SERVICE INFORMATION BULLETIN

APPLICABILITY: All BRZ Models with 6MT
SUBJECT: Pilot Bearing Change

NUMBER: 03-80-18
DATE: 05/10/18

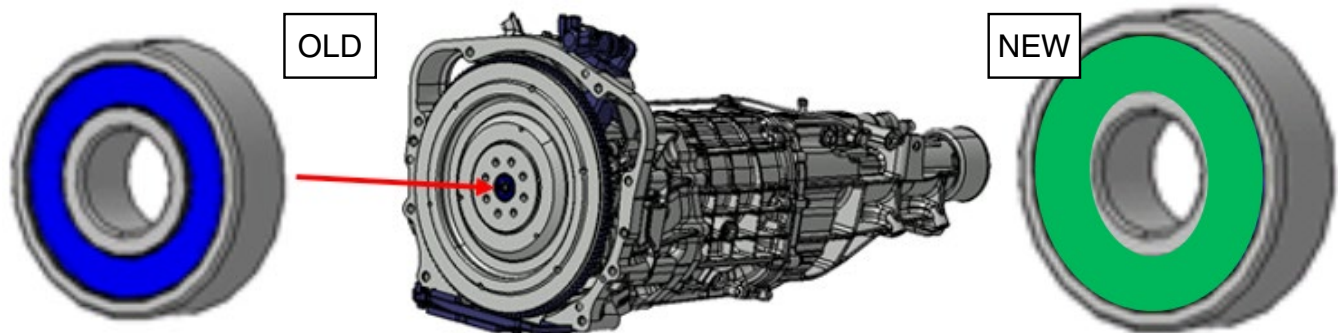
This Service Information bulletin announces a change to the flywheel (pilot) bearing to a “environmentally friendly” type which is compliant with the REACH (Registration, Evaluation, Authorization and restriction of CHEMicals) guidelines being used in the European Union (EU). This change is not intended to address any specific customer concern.

The seal portion of the bearing was changed from blue (old) to GREEN (new) for easy identification.

NOTE: A Blue bearing can be replaced with either Blue or Green but a Green bearing should only be replaced with Green.
